Addendum / Addenda

No./N ^o 1

Project Description / Description de projet M-20 Passenger Elevator Modernization		
Solicitation No./ No de sollicitation 14-22022	Project No./N ^o de projet 3957	W.O. No./N ^o d'ordre de travail 9100030291
Departmental Representative / représentant ministériel Charles Cossette		Date June 10, 2014
<p>Notice: This addendum shall form part of the tender documents and all conditions shall apply and be read in conjunction with the original plans and specifications.</p>		<p>Nota: Cet addenda fait partie intégrale des dossiers d'appel d'offres; toutes les conditions énoncées doivent être lues et appliquées en conjonction avec les plans et les devis originaux.</p>

Project Title:
NRC BUILDING M-20
CENTRE ELEVATOR UPGRADE

Drawing Title:
ELECTRICAL POWER PLAN
PART PENTHOUSE

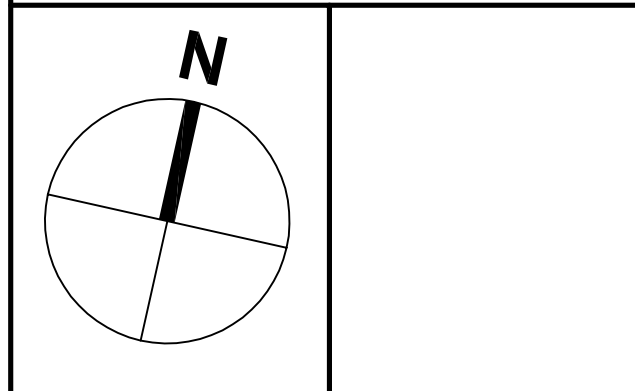
- 1.1.1 Revise the location of existing panel board "P2" in Mechanical Penthouse Room 302 as shown on attached revised drawing #D-3957-E6, Electrical Power Plan Part Penthouse.
